Docket Item # 1
BAR CASE # 2011-0022

ISSUE: Alterations (Window Replacement)

LOCATION: 612 South Lee Street

Figure 5. Proposed basement plan.

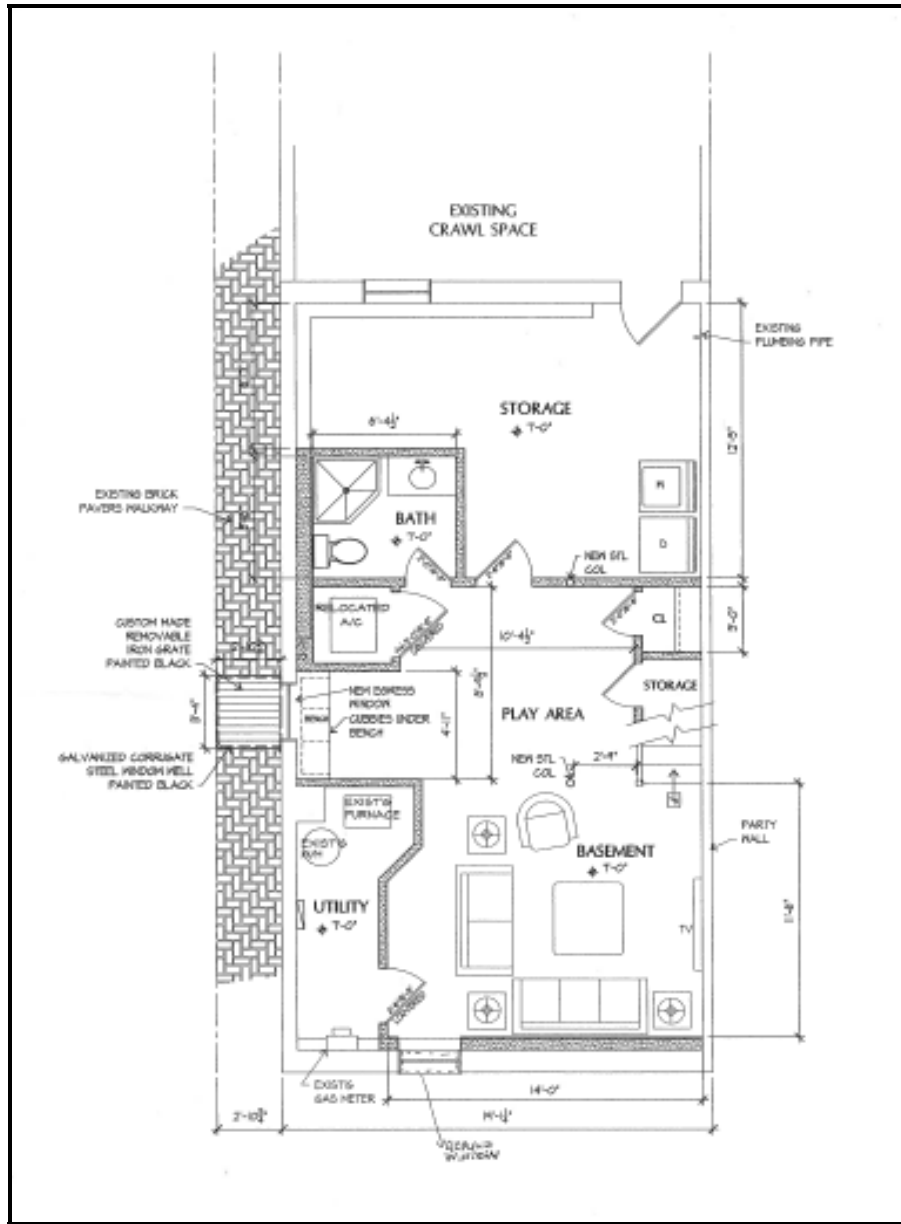
- F-1 The following comments are for BAR review only. Submitted plans are not approved for construction. Subsequent to BAR review and approval the submitted plans will be reviewed for code compliance.
- C-1 A building permit for construction/alteration is required to be issued prior to the start of any work.
- C-2 Five sets of scaled drawings will be required to be submitted for review along with the building permit application. Further details on the proposed new columns, clear window opening, and sill height will be required.

Figure 6. Proposed north elevation.

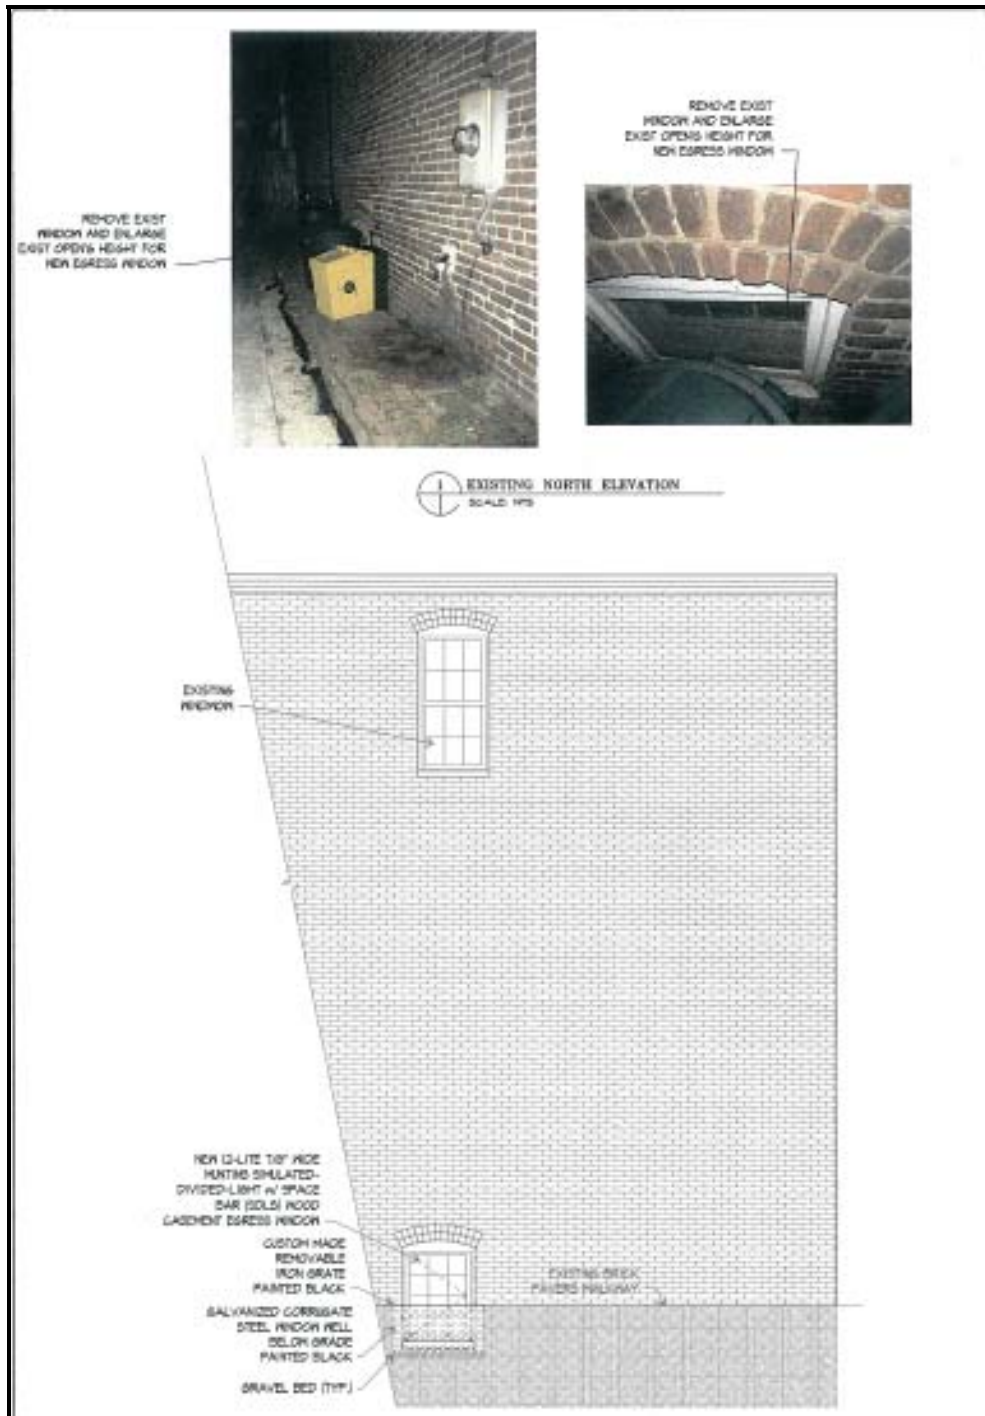
The applicant is requesting approval of alterations at 612 South Lee Street associated with a project to finish the basement in the house. The basement window on the north elevation will be removed and a portion of the foundation below the window will be demolished in order to accommodate a larger egress window, which is a Building Code requirement for habitable space in a basement. The existing brick pavers adjacent to the window will be replaced with an at-grade painted steel grate which must be easily removable for emergency egress. The front basement window facing South Lee Street will also be replaced.

Staff has no objection to the proposed replacement basement window on the front elevation, or the enlarged window opening and new window on the north elevation. The proposed Kolbe & Kolbe windows meet the Board's new Window Policy and the *Alexandria Replacement Window Performance Specifications* with two exceptions. First, the proposed spacer bars are stainless steel. Second, double-glazed windows cannot be installed on buildings predating 1930, when double-glazed windows were invented. In this particular case, given the location of the windows at the basement level and the setback from the right-of-way, Staff recommends approval of the simulated divided light windows. Staff also recommends that the muntin profile – which was not specified – be putty glazed to match the muntin profile of the other windows on the house and that the spacer bars have a non-reflective, medium value color.

STAFF RECOMMENDATION: Staff recommends approval of the application with the condition that the muntin bars have a putty glazed profile and that the spacer bars have a non-reflective, medium value color.
